Royal Clarence Marina Residents Association

20 December 2019

17/00290/FULL | CAR PARKING STRATEGY (AMENDMENT TO CAR PARKING STRATEGIES APPROVED 29.02.08 AND 16.10.15) (CONSERVATION AREA) (as amended by documents received 18.11.19) | Royal Clarence Marina Weevil Lane Gosport Hampshire

North Meadow /Zone 2 Car Park: Lighting levels at night

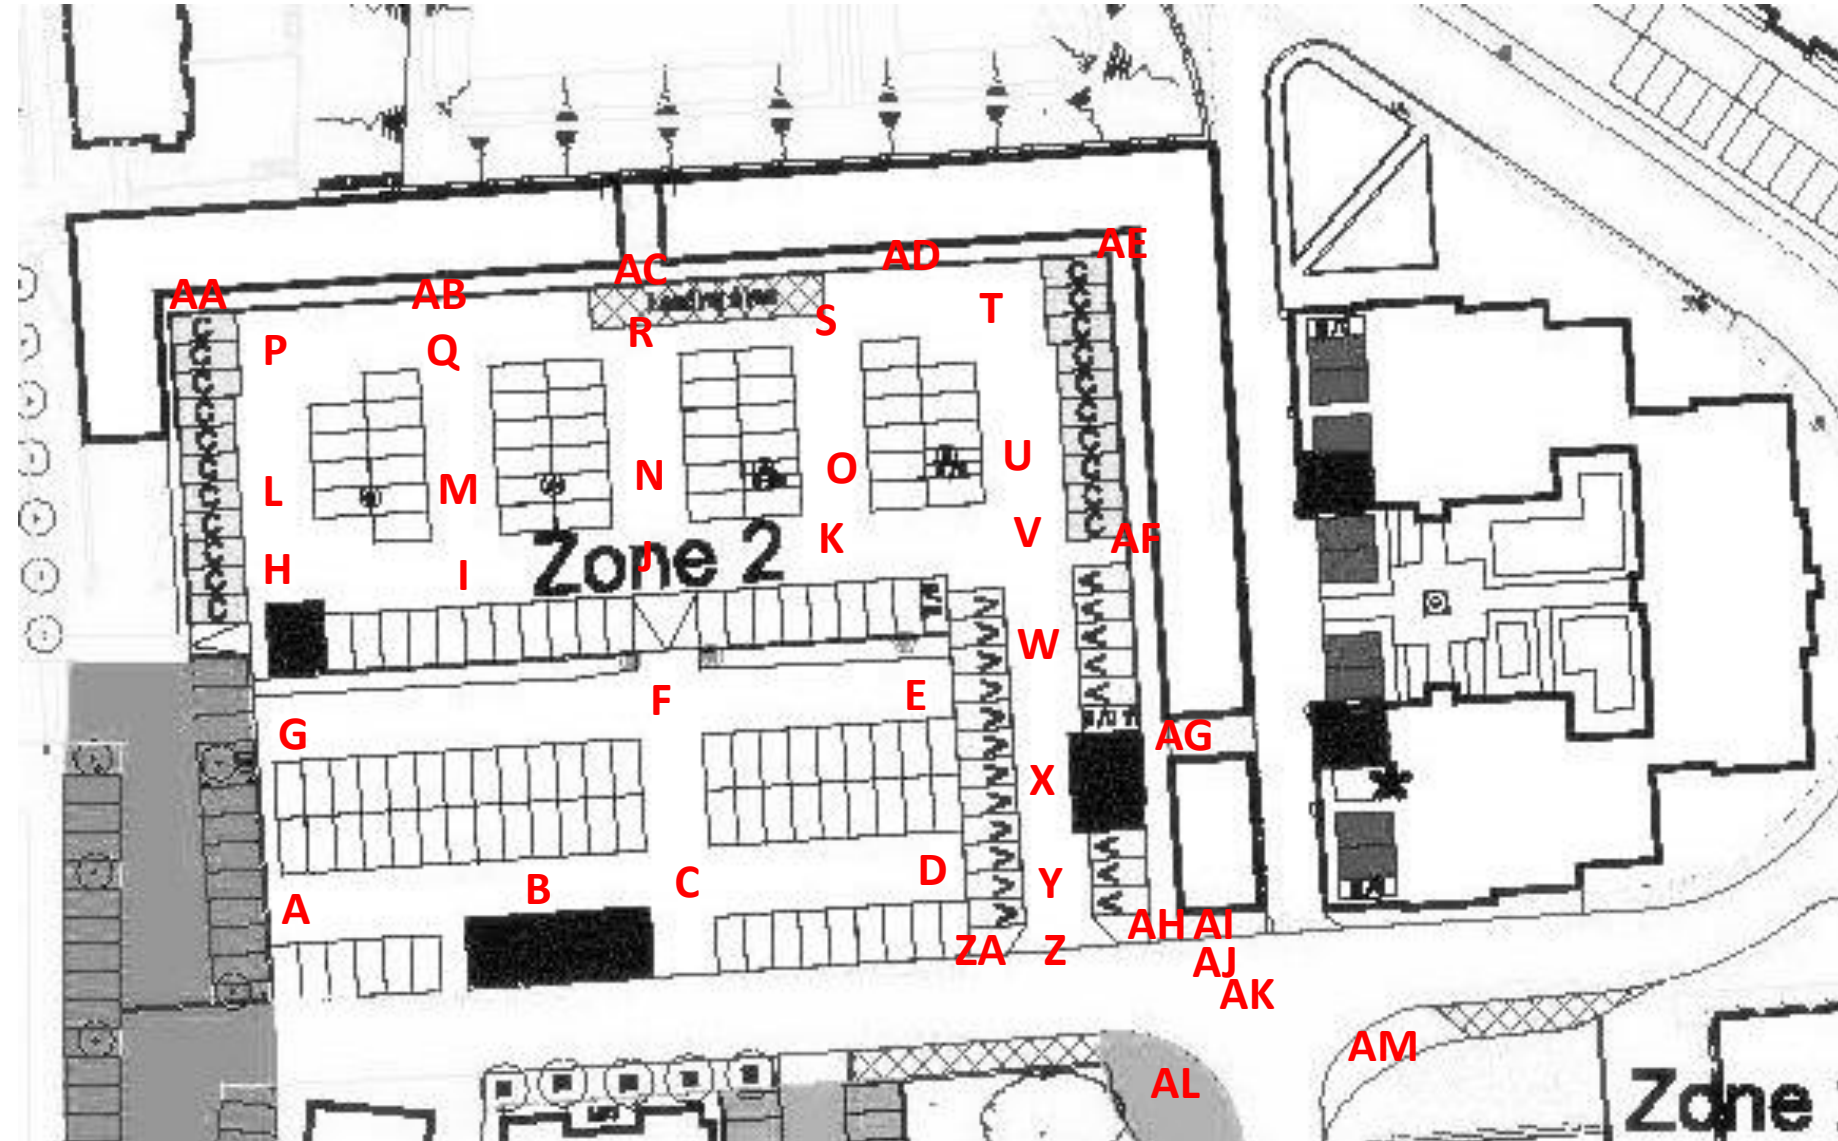
As can be seen from the table of readings attached to this letter, the majority of the North Meadow Car park falls below 2.5lx. The only well lit areas are immediately under the

lighting columns in the rear of the car park and immediately under the (unapproved) additional light attached to the exterior of Unit 12.

There are pools of darkness all round the car park, particularly on the perimeter walkways, disabled access points and the NM4/5 footprint, making it difficult to see kerbs and changes of level.

The crossing from the North Meadow car-park towards Galleon Place and the Waterfront is particularly dangerous as the illumination falls below 2.5lx as soon as a pedestrian steps off the pavement. Driver rounding the corner from the North frequently report difficulties seeing pedestrians at this point due to the low levels of lighting at the crossing point and the blinding glare from the driver-level bollard lighting further along Weevil Lane. Pedestrians are virtually invisible at this point and this is extremely dangerous.

We have not seen any evidence in any plans submitted by the applicant that the lighting across RCY meets any of these standards. If they believe the lighting across the site is compliant with the British Standards, we hope that the LPA is able to require the applicant to produce the evidence so that it can satisfy itself that the lighting meets the safety requirements of LP23 as a minimum and make the place feel more welcoming.
